WARRANTY BULLETIN

Wb98-03

SUBJECT: RELOCATION OF DRIVER'S AREA THERMOSTAT MODULE

FIGURE 3: THERMOSTAT PREVIOUS LOCATION

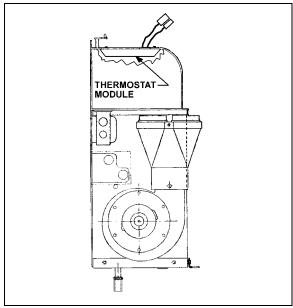
3. Remove and discard four screws securing thermostat module to defroster unit (refer to fig. 3).

- 4. Using four screws (Prévost #500638) fix thermostat module onto bracket (Prévost #064723).
- Cut grommet (Prévost #504356) and insert into bracket hole, channel thermostat module wiring harness through grommet then through defroster unit existing hole. Reconnect thermostat module wiring harness.
- 6. Secure bracket and module assembly using two screws (Prévost #500638) and existing holes farthest from the edge previously used to fasten thermostat module. Thermostat module must face rear of vehicle (refer to fig. 4).
- 7. Replace finishing panel using attaching parts.
